DOCKET 50-255 - LICENSE DPR-20 - PALISADES PLANT -
EXPANSION OF THE SPENT FUEL POOL STORAGE CAPACITY - RESPONSE TO REQUEST FOR
ADDITIONAL INFORMATION

RESPONSE TO QUESTIONS TRANSMITTED BY
NRC LETTER DATED APRIL 25, 1986

TYPICAL REGION I RACK - PLAN VIEW

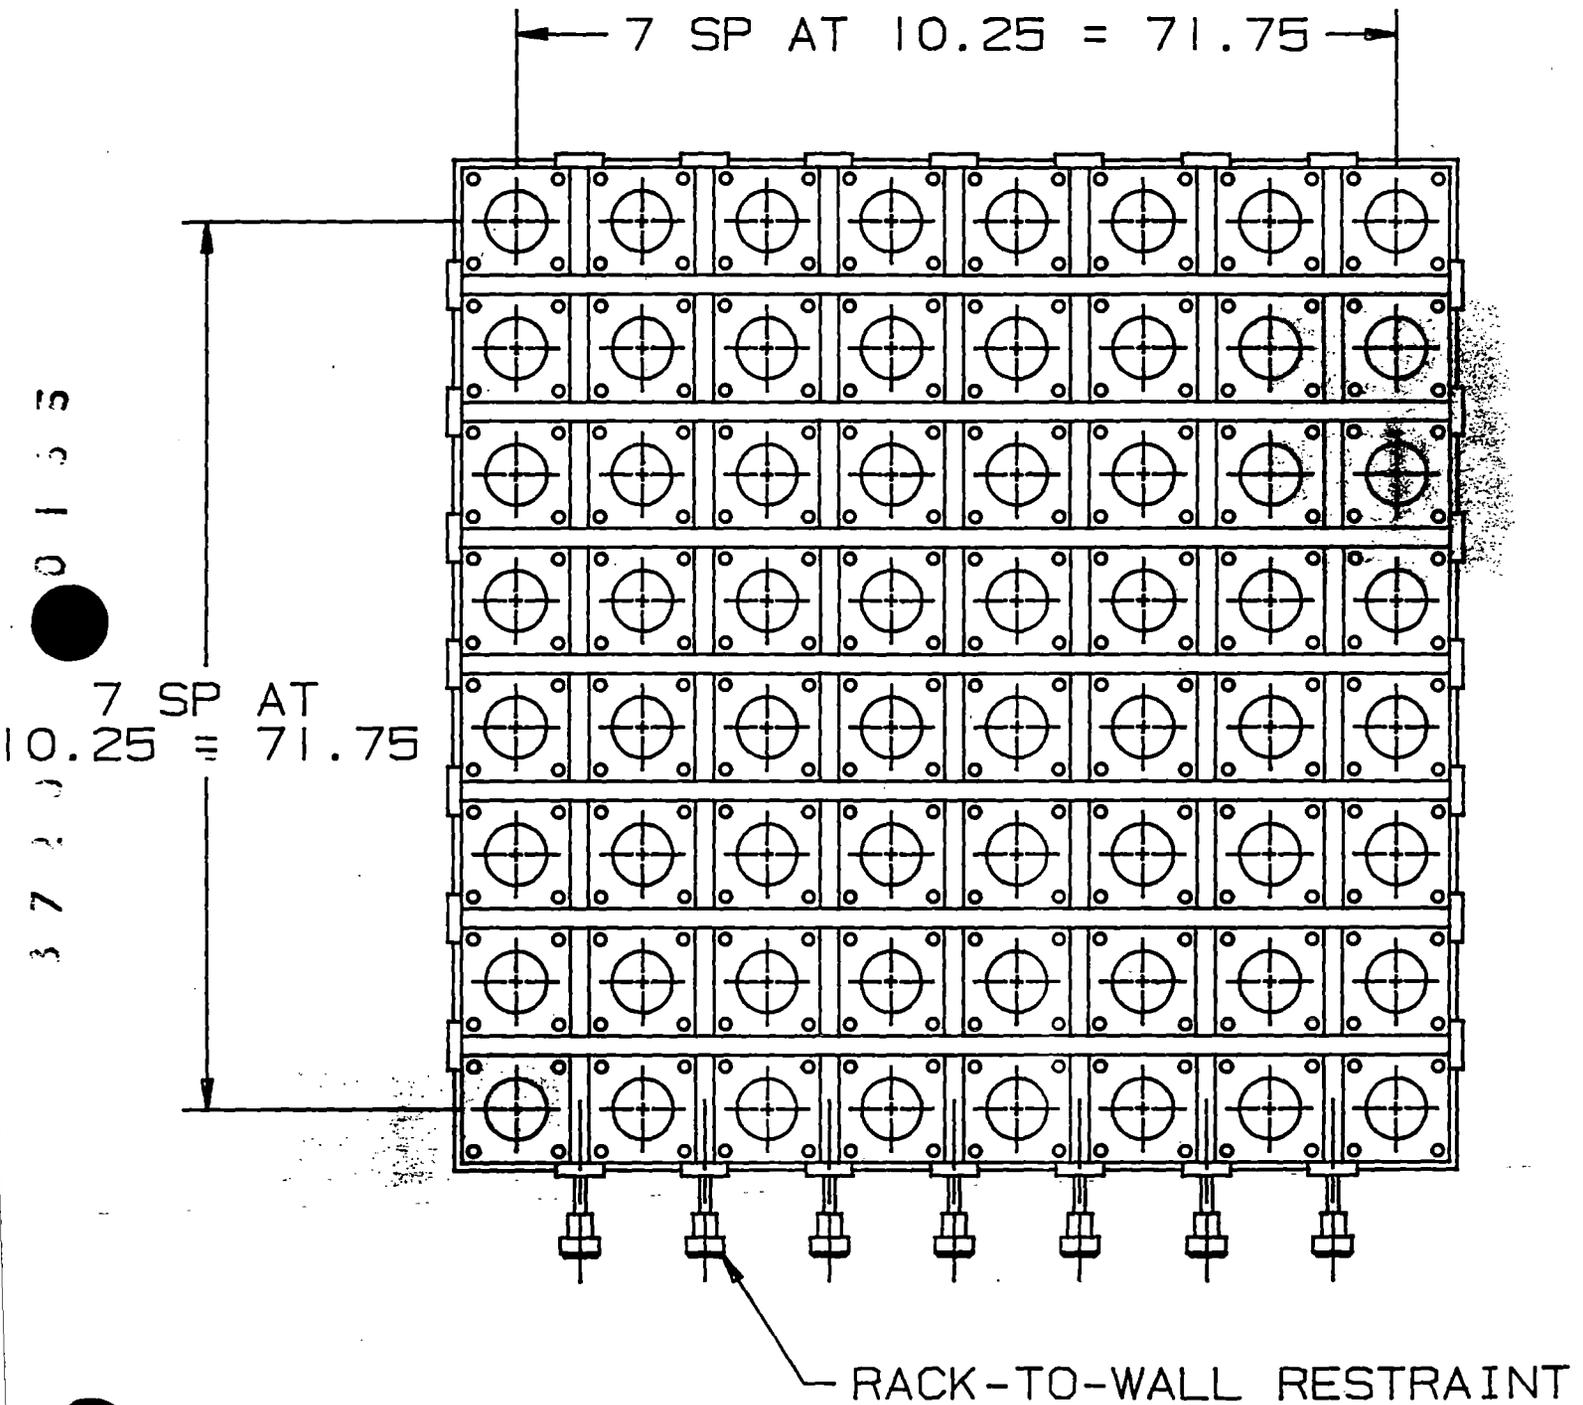
- a. For the Region I racks already in place, provide descriptions and sketches of the fuel racks, their method of lateral restraint (attachment to the pool walls), and a full description of the displacement analysis indicating that the Region I racks will not be displaced to impact the new Region II racks.

The non-linear time history analyses of the Region I and Region II racks show that the maximum relative displacement between the Region I and Region II racks due to sliding, rocking, structural deflection, and thermal effects is 0.54 inches. This is much less than the 1.75 inch minimum clearance and therefore precludes impact between the Region I and Region II racks.

FIGURE 1-10b: RACK MODULE AND MOUNTING PAD DESIGN CHARACTERISTICS

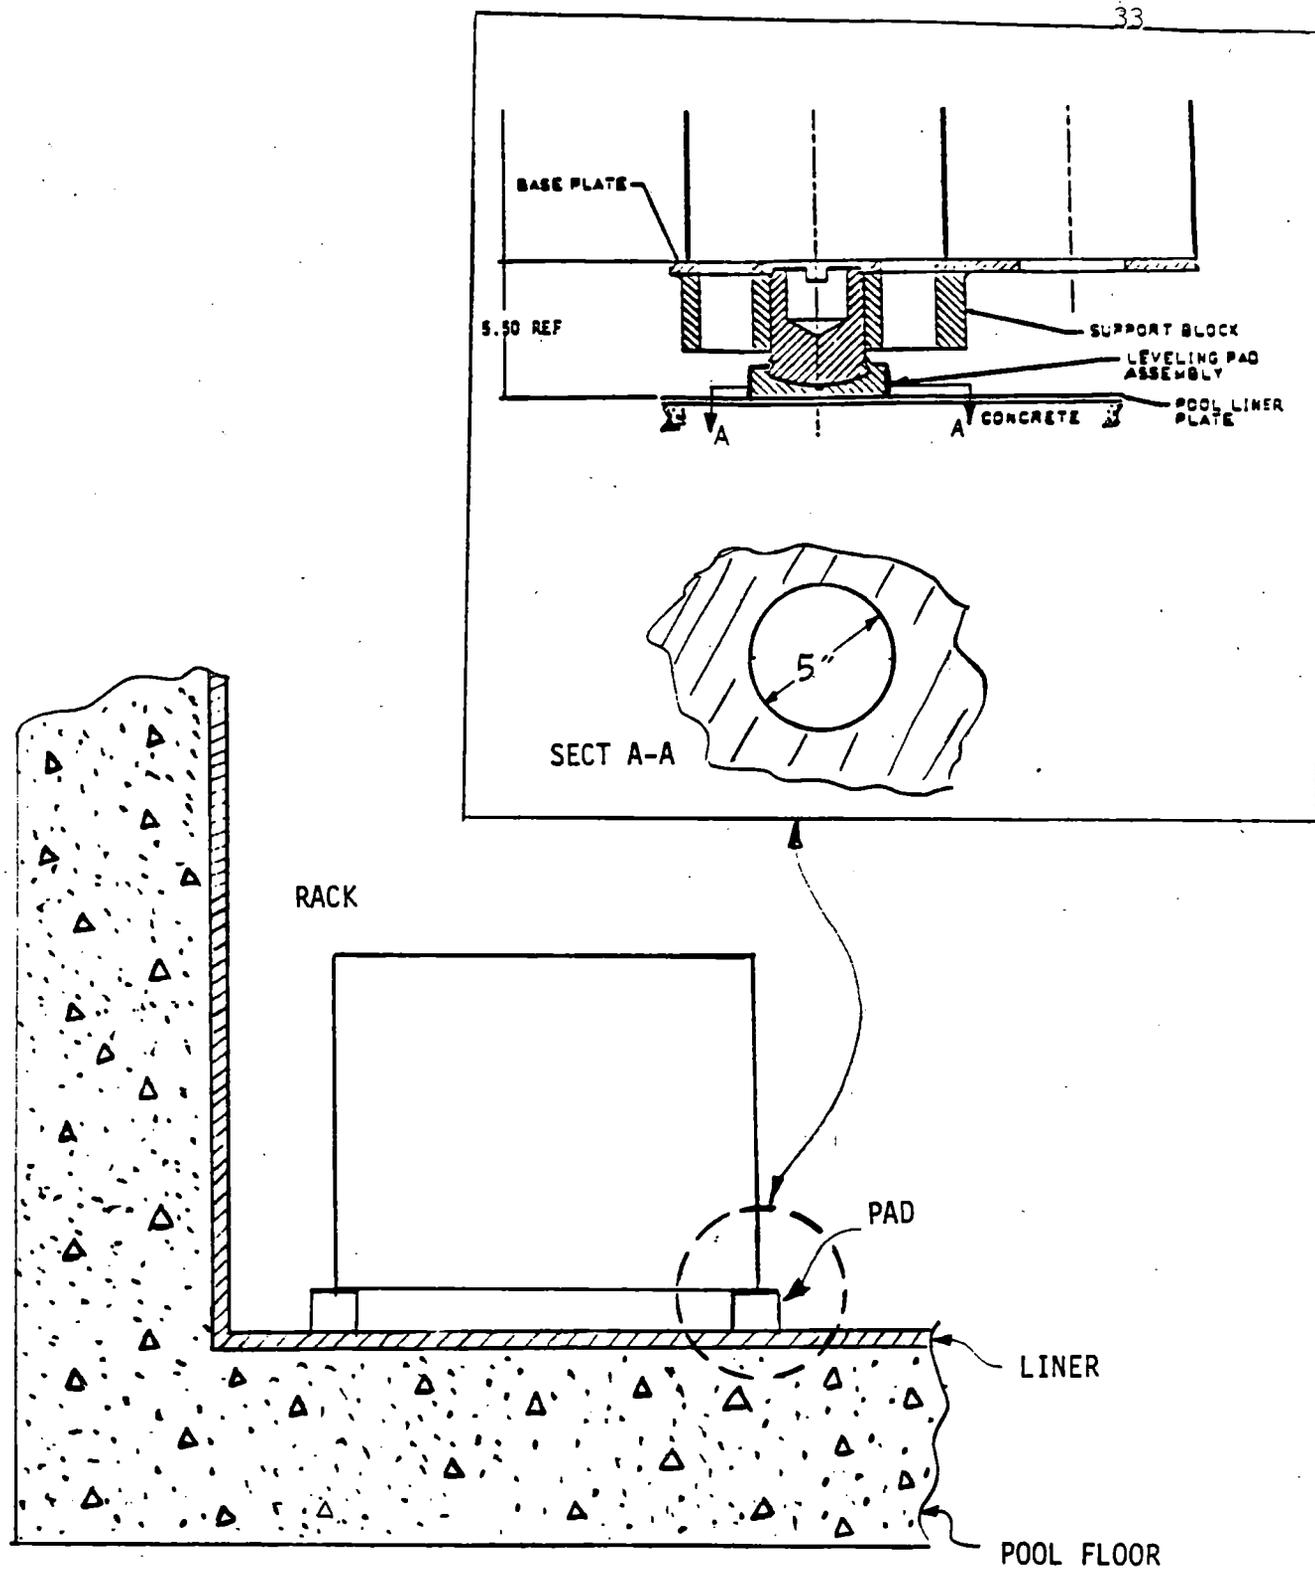
Question 10b: Provide analysis proving the adequacy of the pool floor and liner under the local maximum rack module dynamic mounting foot loads.

Two types of fuel racks (W and NUS) are used in the pool. Both racks are free standing with circular pads used to transfer the rack loads to the pool floor. The basic design characteristics are shown in Figure 1-10b. The W pad and the NUS pad are 5 inches in diameter. The liner on which the pads rest is 3/16 inches in thickness and is SA-167, Type 304L stainless steel anchor plate. The liner rests on the concrete pool floor. This is also shown in Figure 1-10b.

By the nature of free standing rack design, the only way that a horizontal load can be transmitted to the pool floor is by friction. The friction load, as well as the vertical load, is transferred directly to the pool floor at the location of a pad. This is shown in Figure 2-10b. As seen in this figure, two types of local stresses are induced into the liner, shear stress and bearing stress. Since the NUS fuel racks have the highest loads (See Table-10b), the highest local liner stresses will occur at the location of the NUS pads. The maximum local stresses that will be produced in the liner for the defined design seismic events are given in the following.
